# **East Anglia ONE North and East Anglia TWO Offshore Windfarms**

## **Applicants' Comments on Marine Management Organisation's Deadline 3 Submissions**

Document Reference: ExA.AS-17.D4.V1

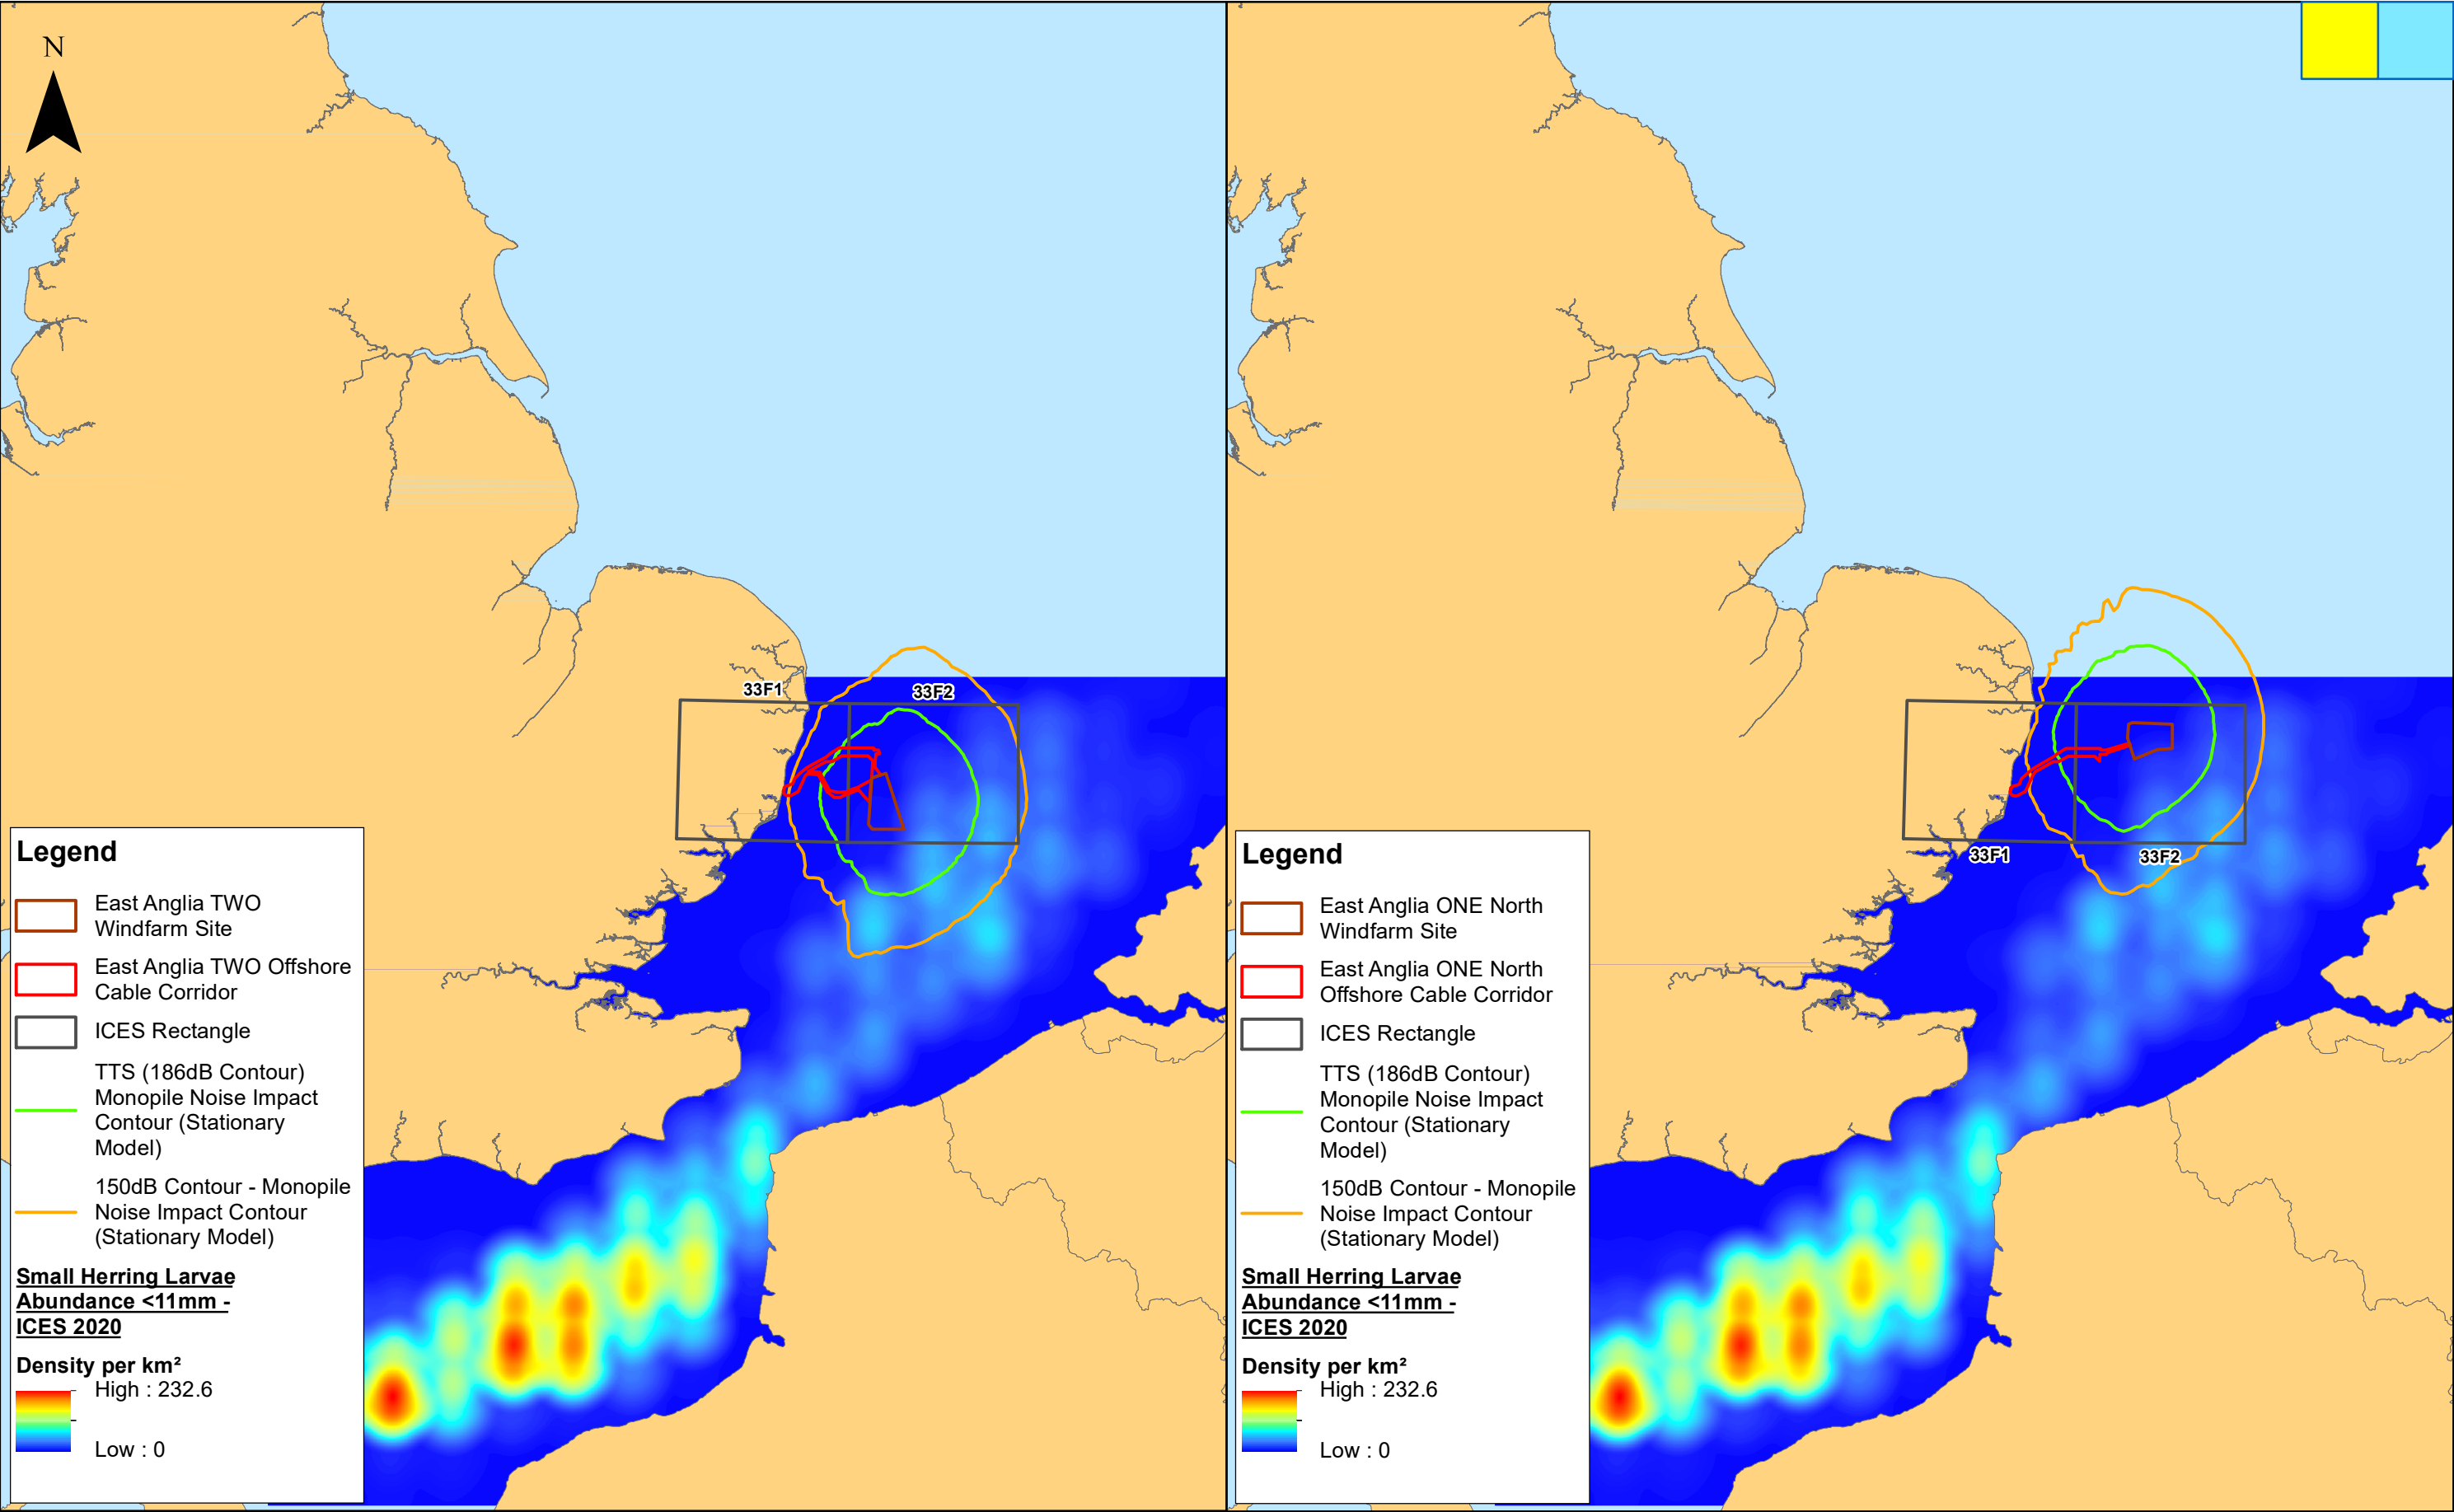
Point	MMO Comment	Applicants' Response
	<p>In addition to this the MMO also thanks the Applicant for presenting the revised underwater noise modelling using a stationary receptor and monopiling scenario, based on the January IHLS survey data (Figure 7). The TTS noise contours show that there is an overlap with areas of 'medium' larval density, indicating that noise and vibration will propagate across the northerly areas of the Downs herring spawning grounds. This correlates well with the IHLS data mapped in Figures 1-3 as discussed above.</p> <p>The TTS noise contours surrounding EA1N and EA2 overlap with areas where 'medium' larval densities typically occur. Whilst this indicates potential impacts to spawning herring and their eggs and larvae, the MMO acknowledges that the overlap is somewhat sporadic and that higher larval densities typically occur further to the South, in the English Channel, during the December spawning period. With this in mind, the MMO does not have any major concerns that the effects from noise and vibration on eggs and larvae will result in significant impacts at a population level.</p> <p>However, the MMO does have major outstanding concerns for gravid adult herring which are likely to exhibit behavioural responses to noise and vibration from piling.</p> <p>It is well understood that there are two migrations of herring stocks which take place in the Southern North Sea; the Banks stock undertake a North to South migration passing through the Southern North Sea during November, whilst the Downs herring undertake migration through the English Channel to the Southern North Sea between December and January. With this in mind, there is a need to determine whether noise and vibration from piling is likely to result in behavioural responses to migrating herring which could impede either the Banks or Downs migrations to their spawning grounds.</p>	<p>For the purpose of the assessment undertaken, in line with the definitions suggested in Popper et al. (2014), these distances were considered as follows:</p> <ul style="list-style-type: none"> <li>• Near: within tens of metres;</li> <li>• Intermediate: within hundreds of metres; and</li> <li>• Far: within thousands of metres.</li> </ul> <p>According to the Popper et al. (2014) criteria for behavioural impacts, species of fish with a swim bladder involved in hearing (i.e. herring) would be at high risk of behavioural impact both near the piling locations (tens of metres) and at intermediate distances (hundreds of metres), and at moderate risk when far (thousands of metres) from the piling location. Herring's substrate specific spawning behaviour means that they are considered to be receptors of medium sensitivity.</p> <p>Popper et al. (2014) note that the U.S. National Marine Fisheries Service uses a criterion for behavioural response of 150dB re 1 µPa (Stadler and Woodbury 2009), but states that it is unclear whether this is a peak or rms level. Hastings (2008), within Popper et al. (2014), notes however that the origin of this number is unclear, and it is not clear if it has any scientific validity. Moreover, the criterion does not specify a particular behaviour, but simply assumes there is the potential for fish to experience a behavioural response.</p> <p>Nevertheless, given the absence of specific advice within the scientific literature or from the MMO on how to model potential behavioural impacts on herring from piling, the 150dB SPLpeak noise contour has been presented for the maximum hammer</p>

Point	MMO Comment	Applicants' Response
	The MMO requests that the applicant presents additional noise modelling depicting the behavioural noise contours based on monopiling for a stationary receptor.	<p>energy for a stationary receptor using monopiles. <b>Figure 1</b> below displays 10 years of IHLS data for the January surveys only mapped against the worst case noise impact (TTS 186dB) and the 150dB contour for a stationary receptor. <b>Figure 2</b> displays the same data but for monthly surveys throughout the entire 2007-2017 period.</p> <p>The 150dB contour extends to a maximum distance of 53.92km from the East Anglia TWO windfarm site and 54.41km from the East Anglia ONE North windfarm site.</p> <p>Taking account of the impact ranges presented in these figures, the overall short duration of piling and its intermittent nature, together with the fact that any effect associated with behavioural impacts would be temporary, the magnitude of effect is considered to be low. Therefore, an impact significance of minor adverse is anticipated. Herring would be at low risk from piling and therefore behavioural effects are not anticipated to result in an impact that would be significant and therefore given the locations of the Projects there would be no pathway to impede either migration. In addition, any mitigation measures to be implemented to reduce noise impacts for marine mammals would be expected to reduce the potential for effects on herring still further.</p> <p>The Applicants note that the MMO are liaising with their advisors Cefas on this matter who were requested to provide further information/maps on the movement patterns of spawning herring in the SNS.</p>
